**The human health impact of the proposed landfill at the  
Nevitt, Fingal: a critique of the health assessment in the  
EIS submitted with the planning application.**

On Day 5 of the Oral Hearing (Friday 20<sup>th</sup> October) hydrogeological consultant for Fingal County Council, RPS Consulting Engineers, introduced a revised cross section displayed on an A3 page. The revised version of the cross section varies significantly from the original submitted in the EIS. The revised cross section clearly shows the landfill footprint overlying gravel. This directly contradicts the assertion in the EIS (Volume 5 Technical Appendices H & I Page 15) which states:

**FINGAL LANDFILL PROJECT**

**GEOLOGICAL CROSS SECTIONS A-A' & B-B'**

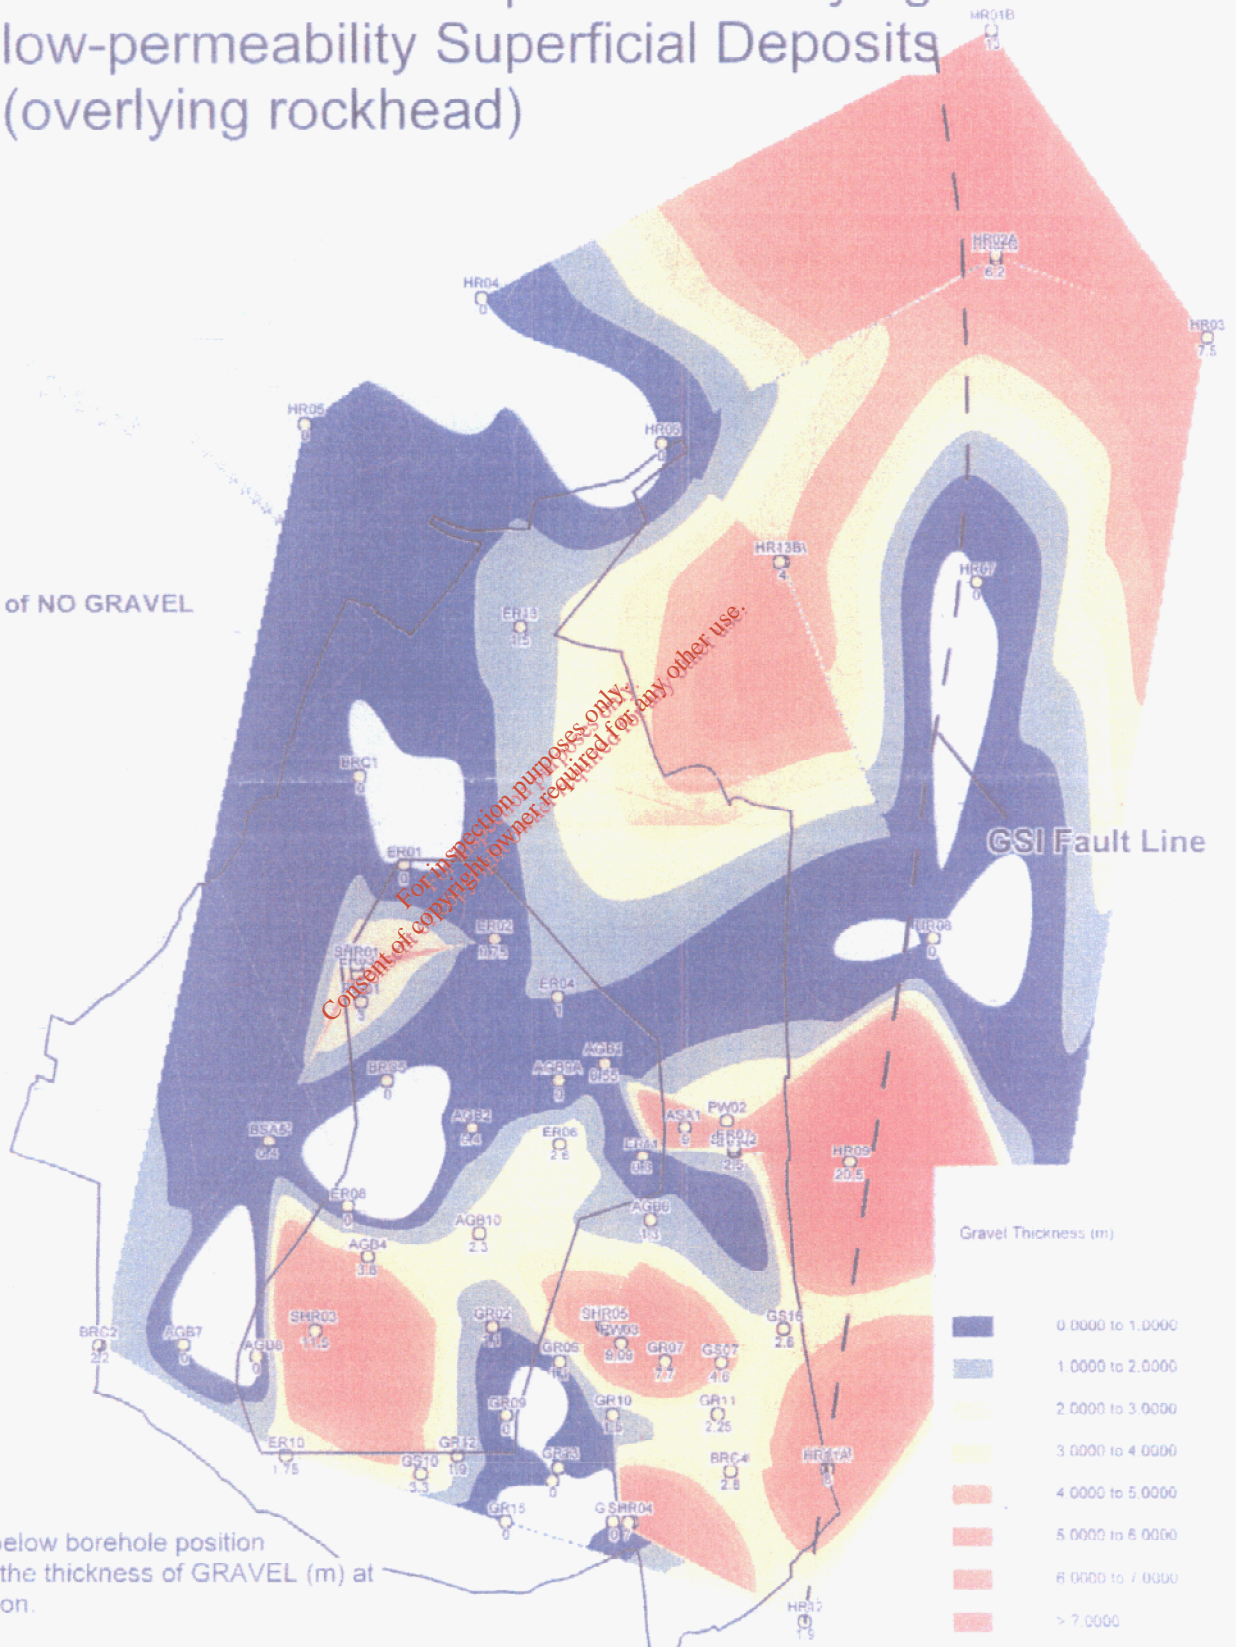
- (b) The map presented by RPS showing the bedrock profile, and the geological cross sections, do not provide additional evidence in support of the proposed landfill. The geological cross sections are far too small to show the thickness of low-permeability overburden that would remain above the gravel and bedrock after construction of the landfill. RPS has still not provided any information in the EIS or subsequently to support their assertion that at least 10 m of low permeability overburden would remain after landfill excavation and construction.

Section A-A' does not pass through the landfill footprint as suggested in Appendix A1.1. As shown in Figure 4 of the EIS Section A-A' passes mostly to the west of the footprint.

The Loughshinny Formation is shown as only 10m thick on Section A-A' while to the north and east of the development site it is shown as being many 100's of metres thick. No such thinning of the Loughshinny Formation is indicated on the GSI Sheet 13.

**Conclusion:** A revised EIS should be published with a series of north-south and east west cross sections through the landfill footprint with a horizontal scale of 1:10,000.

# Proposed Fingal Landfill Bedrock Geology and Rock Level (mod) Profile

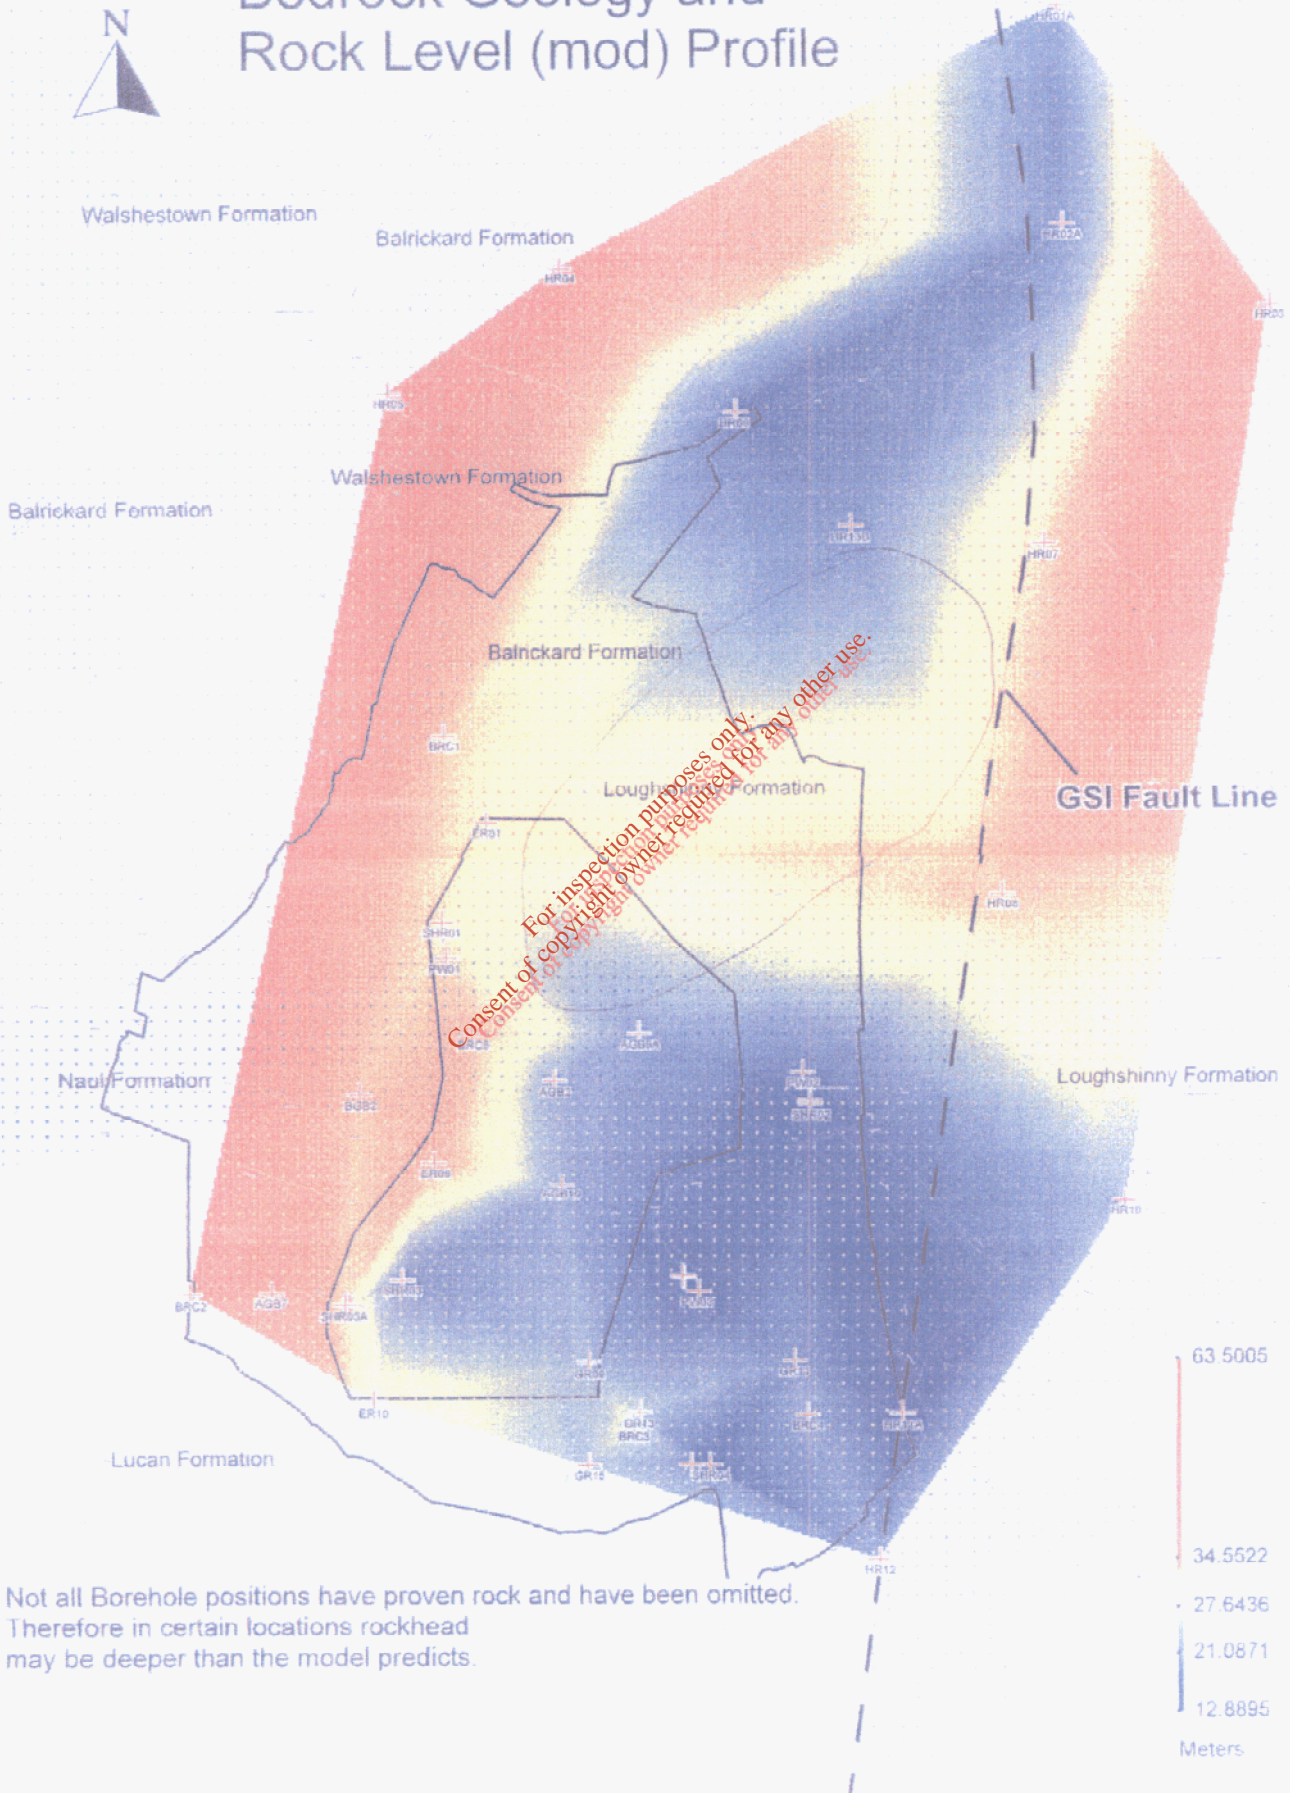
This figure highlights the lack of site specific data that contributed to the conceptual model of the geology presented in the EIS. The lithology distribution and the position of the north-south trending fault are based on information published by the Geological Survey of Ireland. The boreholes drilled on-site have not been used to confirm the positions of the boundaries between the three limestone formations that the GSI indicates underlie the footprint. In addition, the drilling information and the geophysical surveys were not used to refine the position of the north south trending fault. Several 'possible faults' identified by the geophysical investigation were not considered in the EIS and no investigations appear to have been undertaken to confirm their presence or to establish their extent or significance.

This figure indicates that the top of the bedrock is closest to the surface in the west of the landfill footprint and again just to the north of the footprint. It is unclear whether or not this subsurface topography influences the groundwater flow pattern within the area. For example, it is unclear from the EIS if this topographic high within the bedrock acts as a groundwater divide with groundwater moving southeast on the southern side of the bedrock feature and moving northeast to the north of the bedrock feature. It is unfortunate that this information was not included in the EIS and that it was not considered in producing the groundwater contour maps.

- Figure 1      Bedrock Surface and Possible Fault zone
- Figure 2      Possible Extent of Buried Sand & Gravel Deposit
- Figure 3      Groundwater Contours – Bedrock – 17<sup>th</sup> January 2006

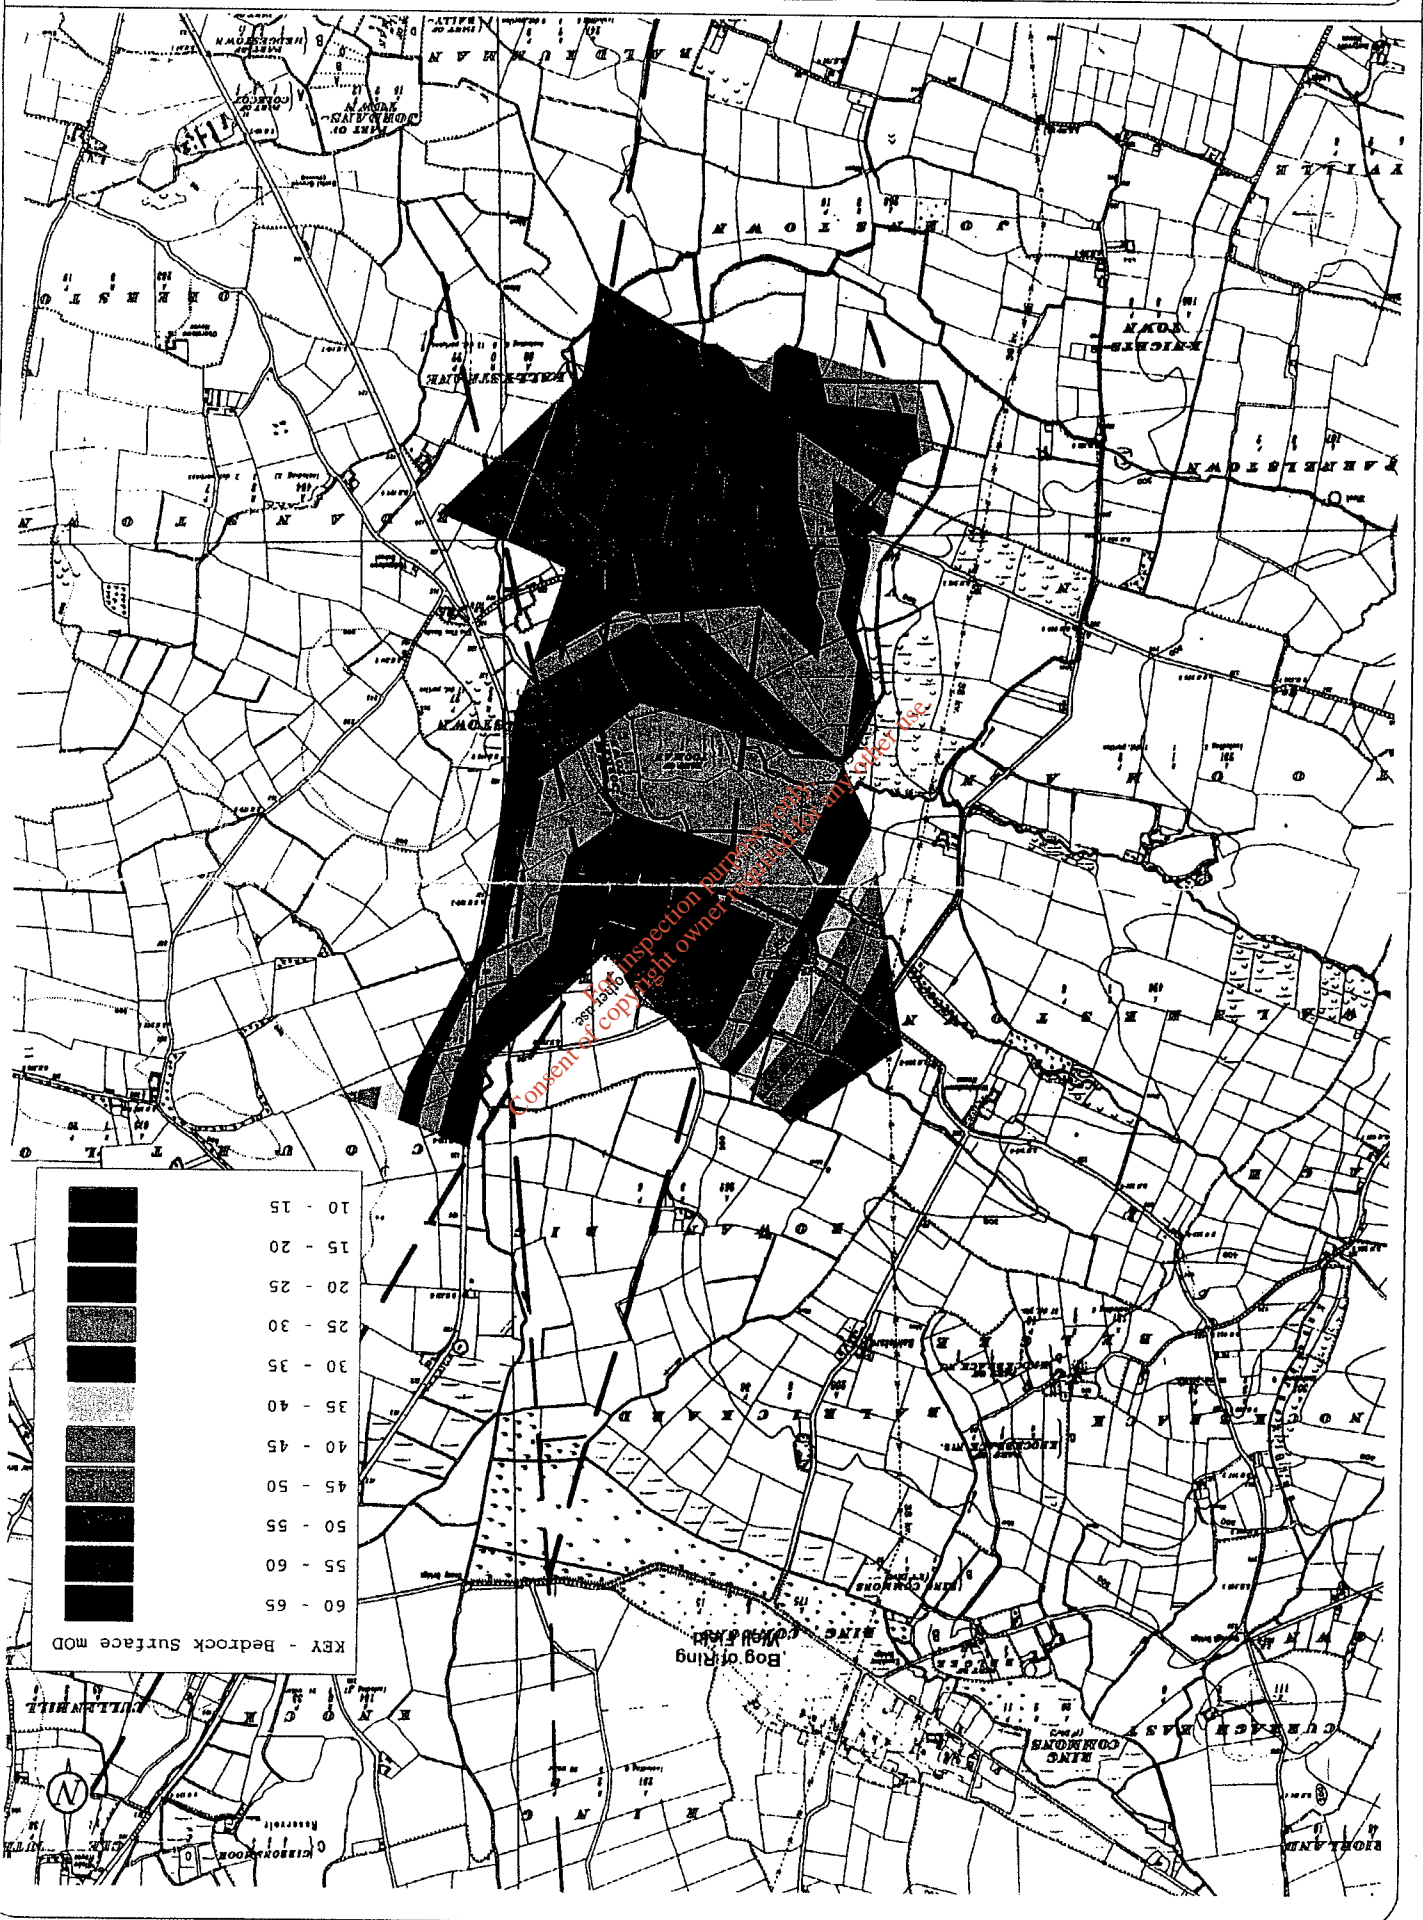
The accompanying Figure 1 shows that a deep north – south trending trough or buried channel is present in the bedrock surface within and beyond the Applicant's study area.

This bedrock trough or buried channel feature is generally coincident with the postulated major north south fault shown by the GSI Sheet 13 as traversing this part of north county Dublin. The bedrock depression probably reflects a weakening or weathering of the bedrock here as a result of the structural deformation associated with the faulting.

The accompanying Figure 1 also shows how the trace of this postulated structural break is associated with a very broad fault zone which extends beneath the landfill foot print. The exact location of the GSI fault remains uncertain as it might define either the eastern or western edge of the bedrock escarpment or be located in the intervening graben like feature.

However, the fault zone presented in the accompanying Figure 1 is more likely to be composed of numerous fault like features and which together account for the structural displacement of the Loughshinny Formation described on the GSI's Sheet 13.

**Conclusion:** A revised EIS should be published with a map at a scale of 1:10,000 showing the contours of the bedrock surface together with the proposed fault lines and Formation boundaries.

- : Extent of Buried Sand & Gravel Deposit
- : Proposed Fault Zone
- : GSI Fault
- : Landfill Footprint
- : Outline of Study Area B

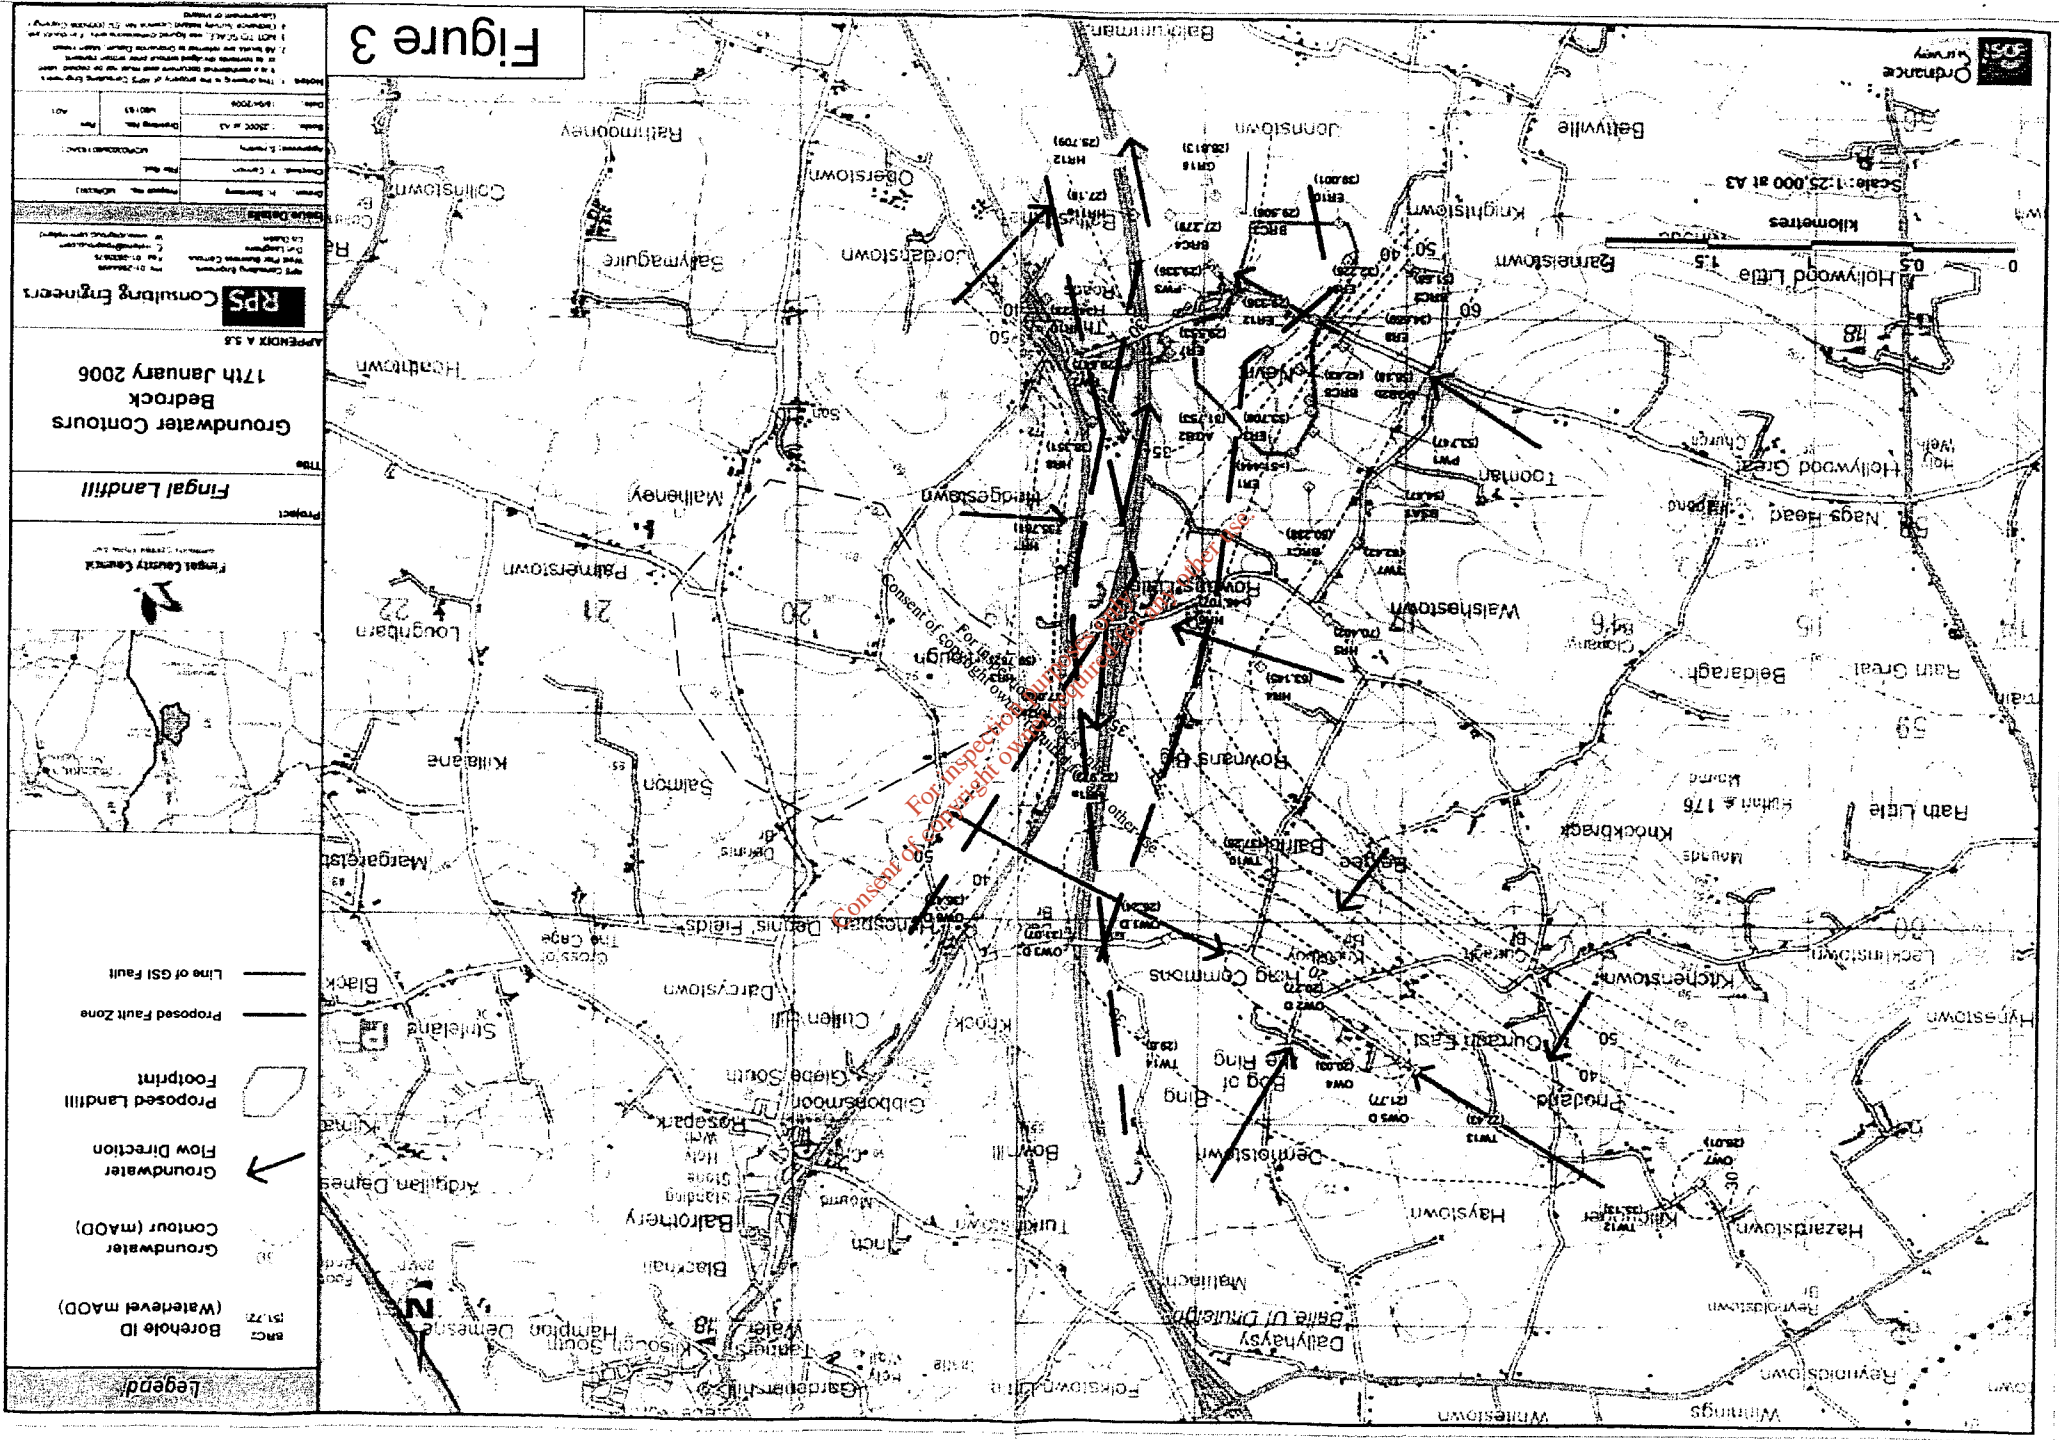
The accompanying Figure 2 indicates the likely extent of this sand and gravel deposit at Nevitt as derived from the borehole logs presented with the EIS. It is obvious from the accompanying Figure 2 that this unit is continuous, very thick in places and open in extent both to the north and south.

Figure 2 shows how the deep bedrock valley outlined on the accompanying Figure 1 is infilled with sands and gravels and which predate the deposition of the overlying glacial till deposits. Figure 2 also indicates that much of the landfill footprint is underlain by the sand & gravel deposit.

**Conclusion:** A revised EIS should be published with a map at a scale of 1:10,000 showing the distribution of the extensive sand and gravel deposit found at Nevitt.
